NUREG-1740

Voltage-Based Alternative Repair Criteria

**A Report to the
Advisory Committee on Reactor Safeguards
by the
Ad Hoc Subcommittee on a
Differing Professional Opinion**

Figure 4. Process Used to Estimate Leakage Rate

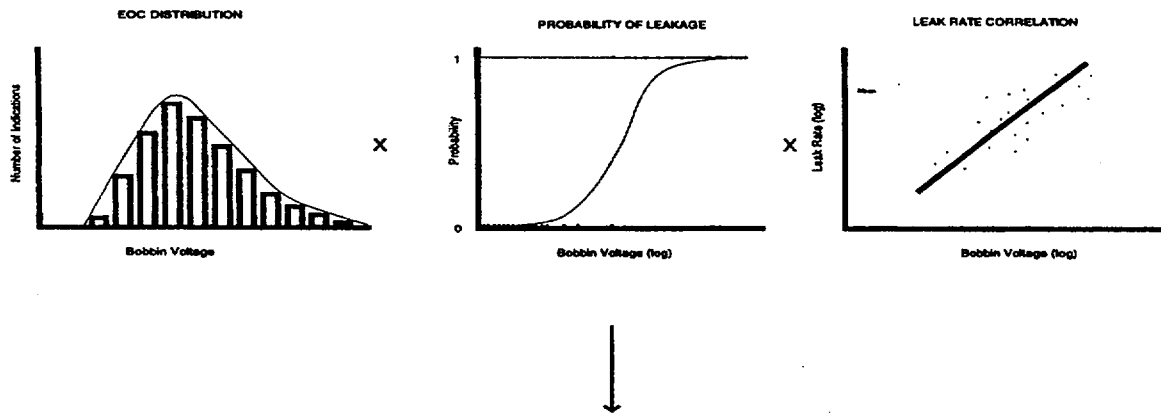
The prediction of the leak rate from tubes in a steam generator during a MSLB accident involves steps shown schematically in Figure 4. The process begins with a determination of a distribution of the number of flaws found during inspection of the steam generator as a function of the magnitude of the voltage signal produced by these flaws. The number of flaws in each voltage interval is increased by a factor equal to the reciprocal of the probability of detection ($1/POD$) of a flaw capable of producing a signal of this magnitude. The resulting distribution is multiplied by the probability that flaws producing signals of a given magnitude will leak. The resulting distribution is then multiplied by the leak rate in each voltage range found from a correlation of the leak rate with signal magnitude. Summation over the various voltage intervals yields a prediction of the leak rate during a MSLB accident.

The staff appears to be relying on a compensation of errors in the process to produce a result that is, overall, conservative. Based on the examples shown to the Subcommittee, the staff-approved procedure is yielding conservative results. The Subcommittee did find that the staff-approved procedure does not readily admit likely improvements in the technologies used to inspect steam generator tubes. A procedure more amenable to change with improving technology would consider the probability of flaw detection to be a function of the magnitude of the signal the flaw could produce and would adjust the number distribution to account for the probability of flaws being present that are capable of producing voltage signals in ranges where none had been found.

Figure 5. Process Used to Estimate the Tube Burst Probability

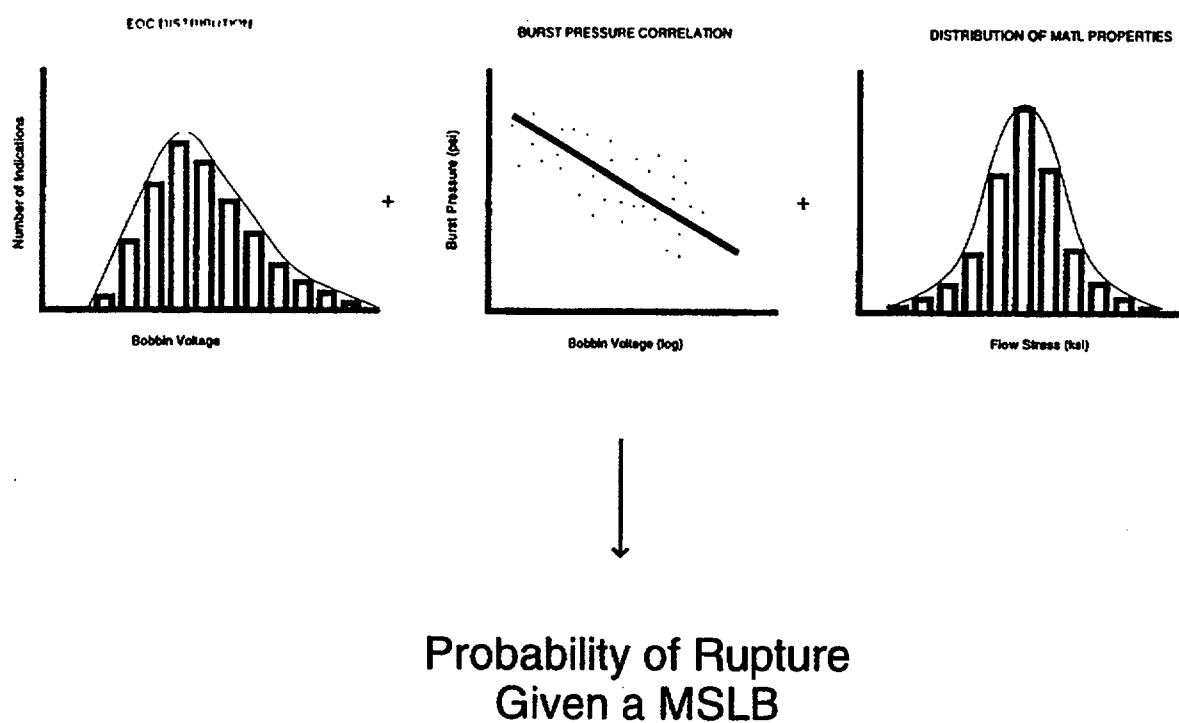
A schematic diagram of the process used for estimating the probability of tube burst is shown in Figure 5. The end of cycle distribution of flaws corrected for the probability of detection and the growth of flaws over the cycle is used just as in the estimation of leakage. This distribution is convoluted with the correlation of normalized burst pressure with voltage. The normalization factor is the flow stress, which is the average of the yield stress and the ultimate stress. The flow stress has a distribution due to the variability of material properties, so the analysis is done using Monte Carlo methods. The Ad Hoc Subcommittee did not examine the distribution of the flow stress. It did examine the correlations of burst pressure with voltage.

The Ad Hoc Subcommittee also examined the database in terms of the sources of the data. Data obtained from tubes flawed in model boiler tests constitute much of the data available for higher voltage signals. These data mesh smoothly with the lower voltage data obtained from tubes removed from service. That is, there was no readily apparent indication that the two data sources yielded results that were indicative of radically different population distributions for flaws.

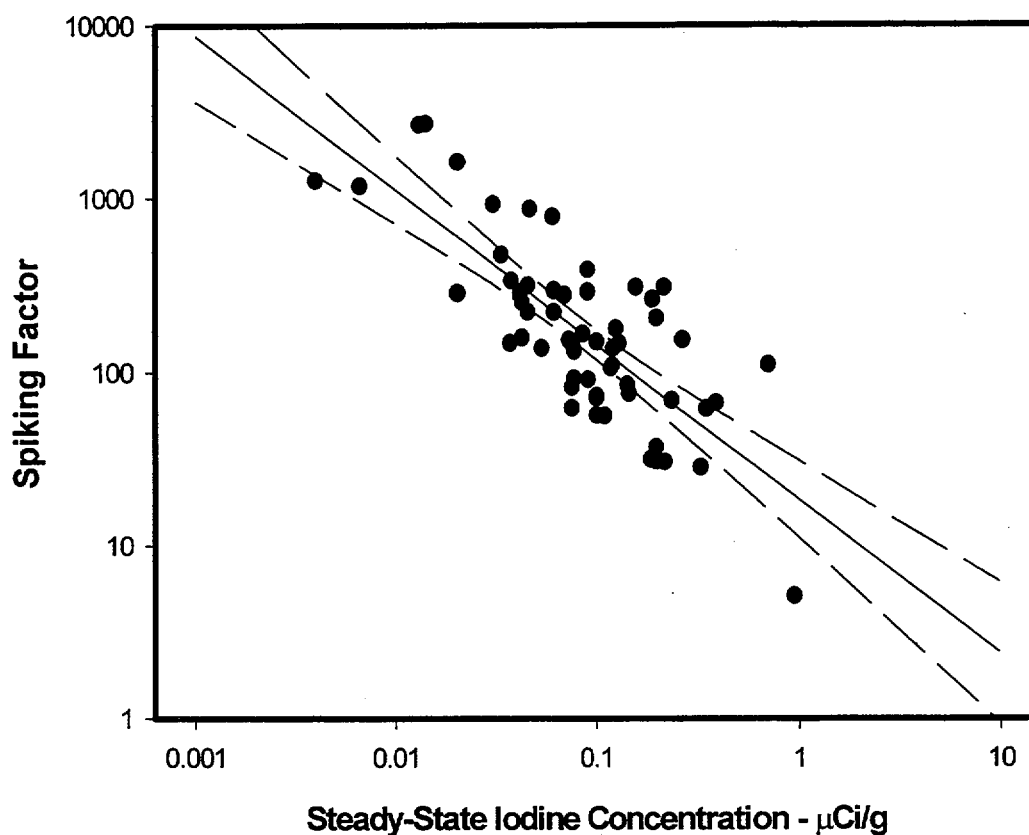
The DPO author contends that the spiking factor used for the accident analyses is too low when the Technical Specification limit on the iodine concentration in the coolant during normal operations has been reduced. He argues that the spiking factor increases with decreasing steady-state iodine concentration. Data collected and reviewed by Atwood and Sattison [17] substantiate the claim made by the DPO author (See Figure 6). A phenomenological understanding of this correlation

where $N = 58$ is the number of data points used to construct the correlation. These bounds are indicated in Figure 6 by the dashed lines on either side of the solid line calculated from the correlation.

The DPO author rightly contends that the iodine spiking factor seems to exhibit a correlation with the initial iodine concentration in the coolant. But, it might be argued that for accident analyses the appropriate spiking factor to use is that found from the empirical correlation using the actual operational iodine concentration rather than the Technical Specifications limit adopted by the licensee, whether it is 1.0 $\mu\text{Ci/g}$ or 0.01 $\mu\text{Ci/g}$. Such a procedure would be inconsistent with the approaches that have long been used in the analysis of design basis accidents. The Ad Hoc Subcommittee also believes that the empirical, linear correlation of spiking factor with initial iodine concentration to the very low initial iodine concentrations typical of many plants today without explicitly accounting for data uncertainties and variations in the mechanisms that lead to operational levels of iodine in the coolant is without sound technical foundation.

Data are available to develop a correlation of the spiking factor with steady-state iodine concentration for analysis of steam generator tube rupture events. If this is done, the correlation should be used with whatever Technical Specification limit on the iodine concentration has been adopted by a licensee rather than the operating iodine concentration typical of the plant. This will maintain consistency with past practices in the analyses. If the staff continues to believe that the spiking factor is greater in a main steamline break because of high differential pressures, another specification of the spiking factor needs to be developed. The Ad Hoc Subcommittee believes, however, that it would be better for the staff to develop a more realistic mechanistic understanding

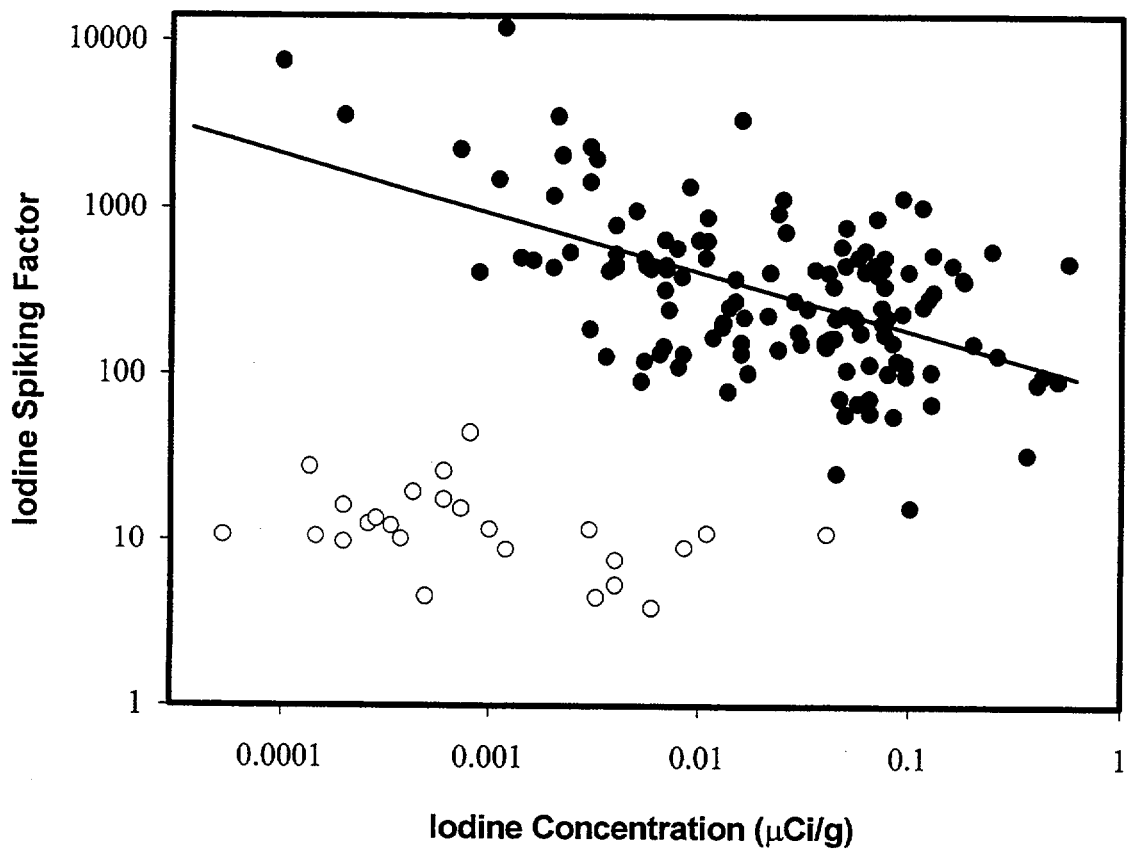
The staff provided the Ad Hoc Subcommittee with an expanded data set on spiking factors. The pedigree of this database is uncertain, but it definitely is not the database used to prepare plots of spiking factor as a function of the initial, steady-state iodine concentration of the coolant shown to the Subcommittee and included in the staff's responses to the DPO. This database seems to be composed of two populations (See figure 7). In one population, the spiking factor does exhibit a dependence on the initial, steady-state iodine concentration. Spiking factors from the other
